ARM Group LLC

Re: Comment Response Letter:
Phase II Investigation Work Plan (Revision 0)
Area B: Parcel B9
Tradepoint Atlantic
Sparrows Point, MD 21219

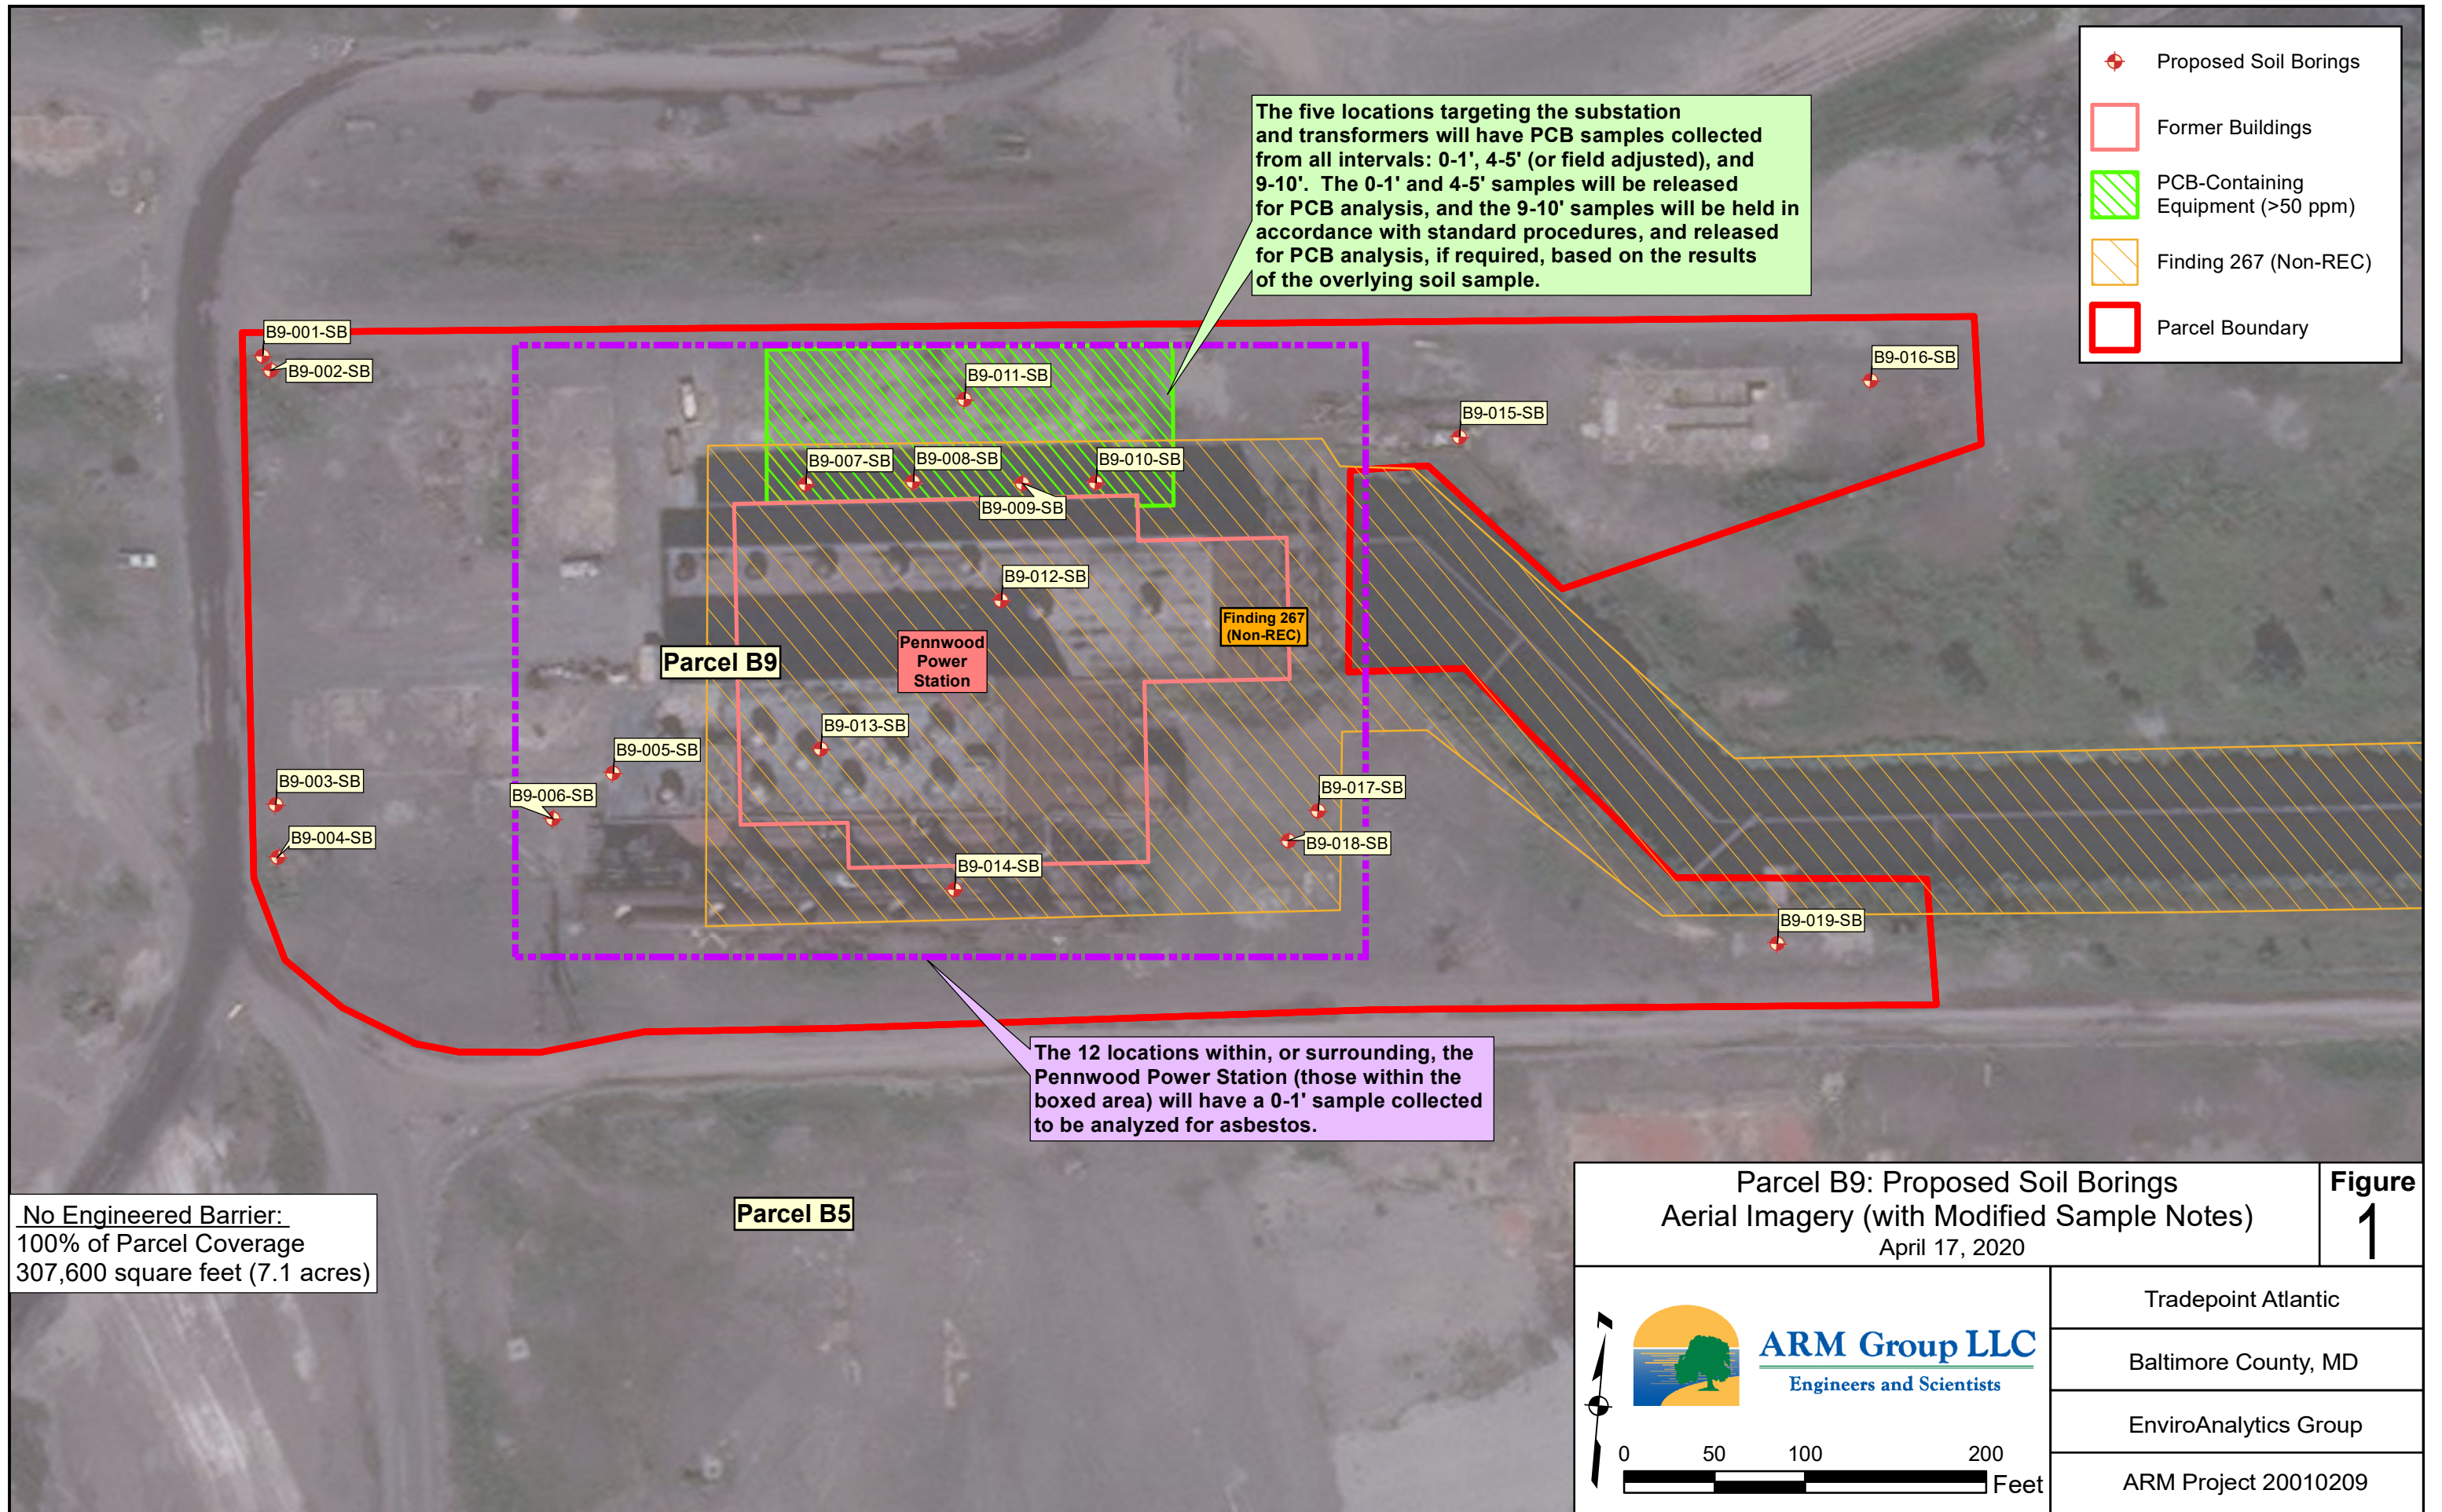
1. *Deeper PCB sampling in the vicinity of the former transformers and nearby areas should be conducted (4 to 5 foot depth) to ensure that PCB contamination was not inadvertently buried during grading and demolition activities for the Pennwood Power Plant and surrounding structures.*

2. *Add asbestos sampling to the shallow 0 to 1 foot sample locations surrounding the former Pennwood Power Plant.*

The locations targeting the substation and transformers to the north of the Pennwood Power Plant (B9-007-SB through B9-011-SB) will have an additional soil sample collected from the intermediate (4 to 5 foot or field adjusted) sample interval to be analyzed for PCBs. An additional soil sample will be collected from the deepest (10 foot) sample interval if groundwater has not been encountered, and will be held for analysis of PCBs in accordance with standard procedures. The deepest soil sample will be released for PCBs analysis, if

required, based on the results of the overlying intermediate soil sample. It should be noted that no soil samples will be collected from a depth that is below the water table. The five locations targeting the substation and transformers are identified for the specified PCB sample collection on the attached **Figure 1**, and a revised sampling plan table is provided as **Attachment 1**.

The previous version of the Work Plan specified that the locations directly targeting the Pennwood Power Plant (B9-012-SB through B9-014-SB) would be analyzed for asbestos in the shallow (0 to 1 foot) sample interval. In addition, the surrounding locations B9-005-SB through B9-011-SB, and B9-017-SB and B9-018-SB will also be analyzed for asbestos in the shallow sample interval in accordance with this comment. These locations are identified for asbestos analysis on the attached **Figure 1**, and a revised sampling plan table is provided as **Attachment 1**.
